ADDENDUM #1

**WESTERN KENTUCKY REGIONAL
INDUSTRIAL DEVELOPMENT AUTHORITY**

FOUR STAR INDUSTRIAL PARK

**SEWER LINE EXTENSION
TO "BUILD READY" SITE
CONTRACT 6**

DETAIL- INSIDE DROP CONNECTION

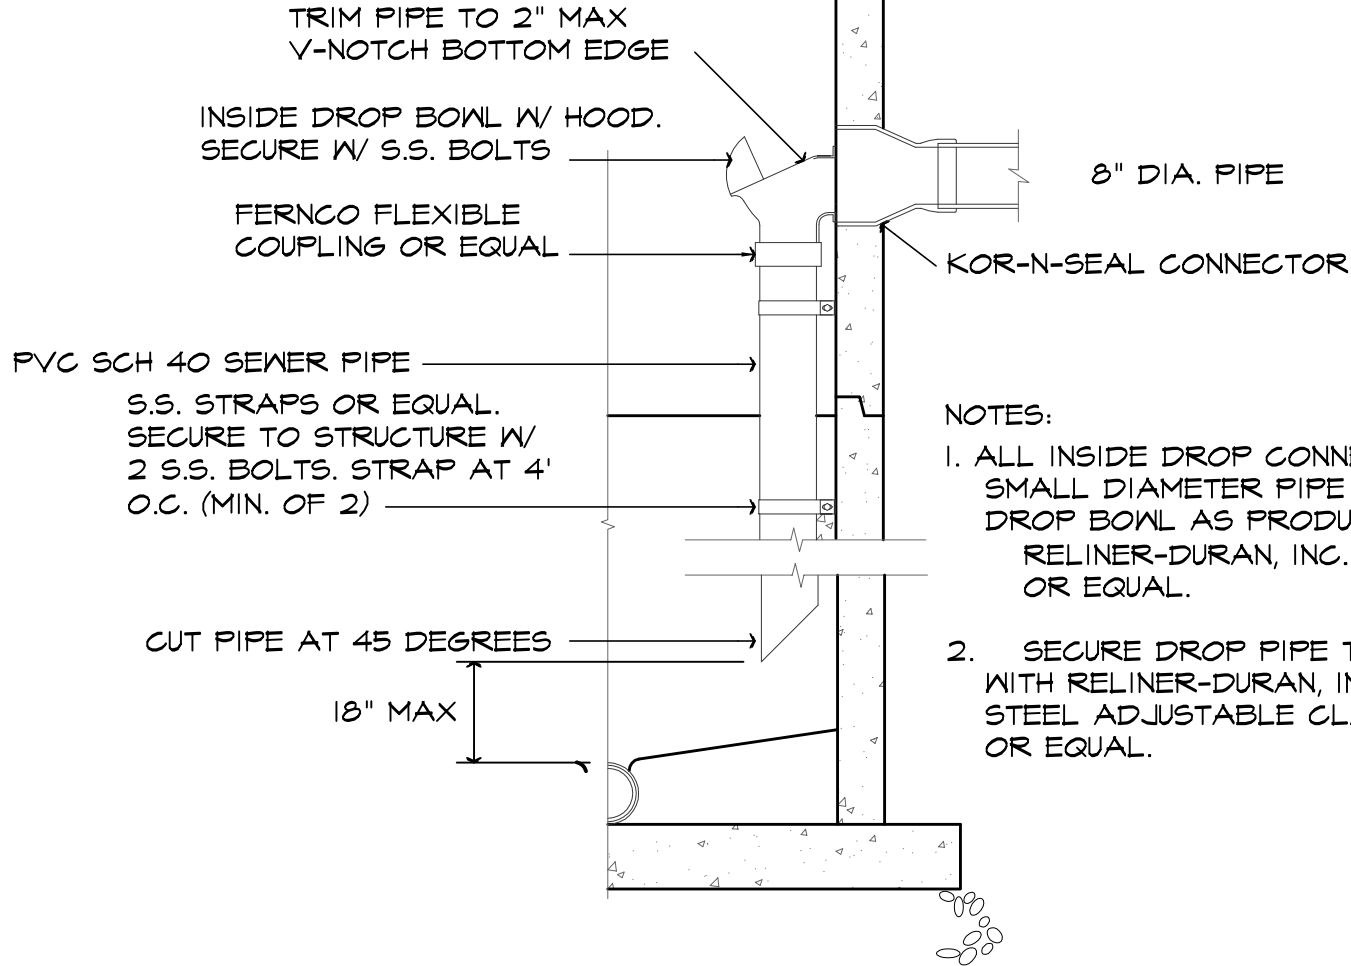
1. Reference the note on sheet C-1 in the plan view at the existing wet well. The Owner will be responsible for payment of the tap fee to H.W.U.
2. H.W.U. has advised that the contractor will be responsible for installing the interior drop pipe in the existing overflow storage wet well. The wet well is reported to be approximately 18 feet deep. The drop pipe is to be included in the cost of Bid Item 8 which is for the connection to the existing wet well overflow storage manhole. "Reshaping the invert" as described in the bid item is not a requirement. The inside drop shall be installed as shown on attached detail.

1. ALL INSIDE DROP CONNECTIONS FOR SMALL DIAMETER PIPE SHALL USE THE DROP BOWL AS PRODUCED BY:
RELINER-DURAN, INC. (800) 434-0277 OR EQUAL.
2. SECURE DROP PIPE TO MANHOLE WALL WITH RELINER-DURAN, INC STAINLESS STEEL ADJUSTABLE CLAMPING BRACKETS OR EQUAL.
